STAIRWAY  
1921 COLONIAL DRIVE  
ORLANDO, FLORIDA

SHEET  
SITE  
1 OF 1

PROPOSED PARKING LAYOUT ~ 1921 E. COLONIAL DR.

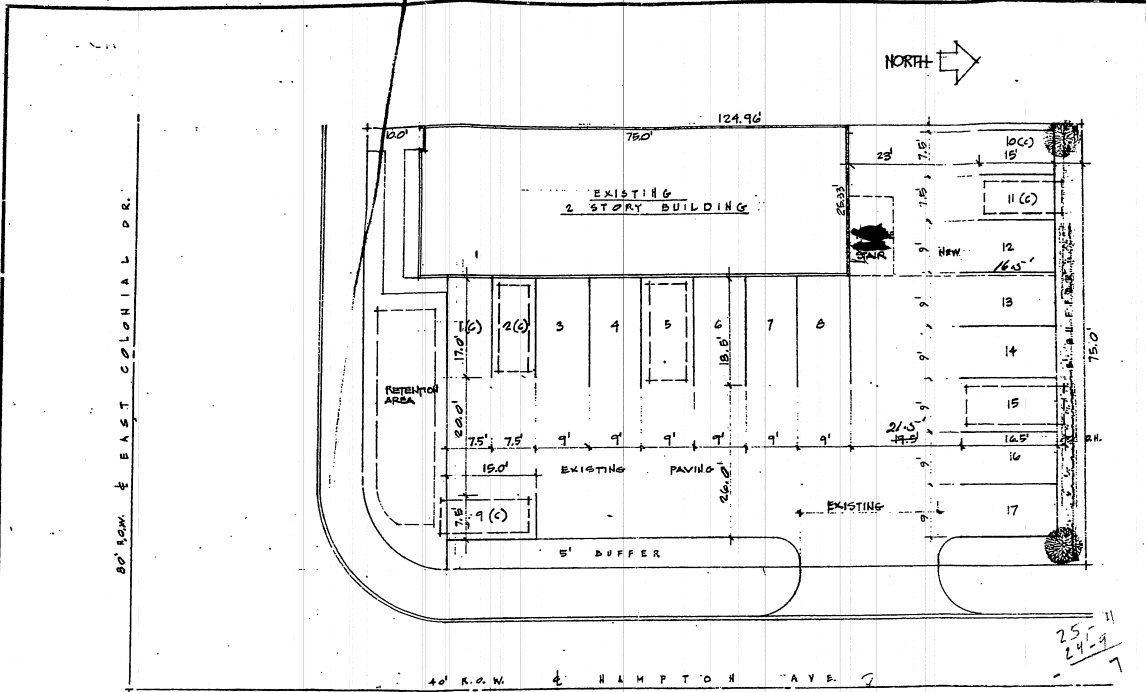
THESE PLANS NOT APPROVED  
ELECTRICAL CONTRACTOR MUST  
SUBMIT PLANS FOR APPROVAL  
AND PERMIT

THESE PLANS NOT APPROVED  
MECHANICAL CONTRACTOR  
MUST SUBMIT PLANS FOR  
APPROVAL AND PERMIT

THESE PLANS NOT APPROVED  
PLUMBING CONTRACTOR MUST  
SUBMIT PLANS FOR APPROVAL  
AND PERMIT

INTERIOR FINISH MATERIALS MUST CONFORM  
TO SECTION 704 S.B.C.

All Prestations of Required Fire  
Rated Ceilings And Walls Must Be  
Protected With Approved Accessories

SEE SEC. 68.116 ORLANDO CITY  
CODE FOR REQUIREMENTS AND  
DETAILS FOR LANDSCAPING  
VEHICLE USE AREAS.

DECORATIVE TREES MAY BE SUB-  
STITUTED FOR US TO A MAXIMUM  
OF 50% OF THE N.E. 5' HIGH.  
TREES SHALL BE REPLACED FOR  
EACH SPACE THE REPLACED.
